**Subject: CZ-19-0673-42 – Design Build Construction of Heating, Ventilation, and Air Conditioning (HVAC) at Multiple Sites – Package A (SDUSD Project # 92790071.1)**

**Notice to Proceed: No. 12R2– HVAC Construction at Torrey Pines Elementary School**

## CONST. CHANGE DIRECTIVE-Type A

**Title:** Delete Gas Seismic Valve  
**Project:** Torrey Pines HVAC Phase 2  
**From:** San Diego Unified School District  
**To:** Soltek Pacific

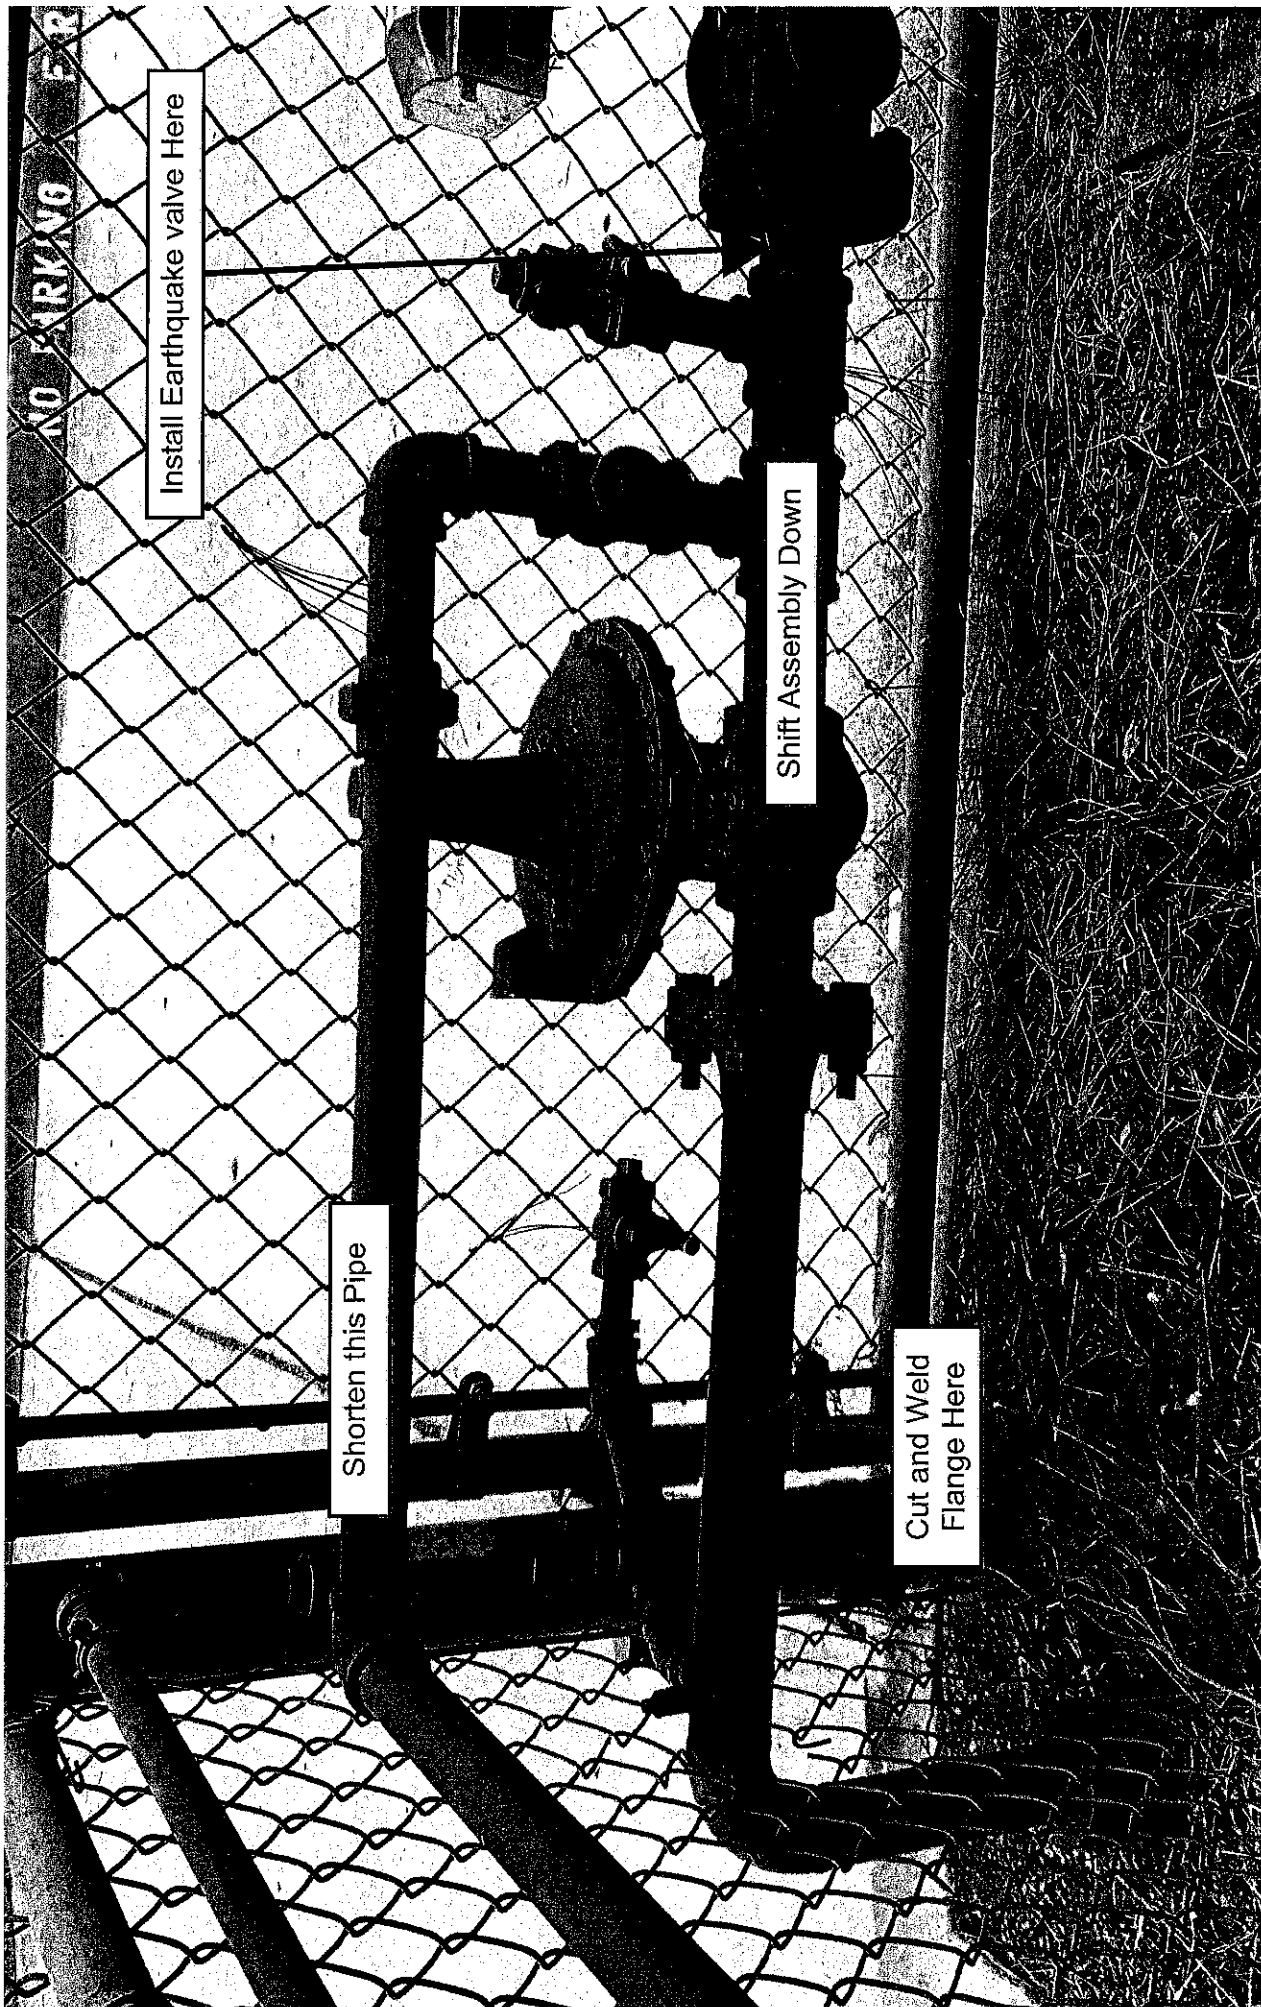
Install Earthquake valve Here

Shorten this Pipe

Shift Assembly Down

Cut and Weld Flange Here
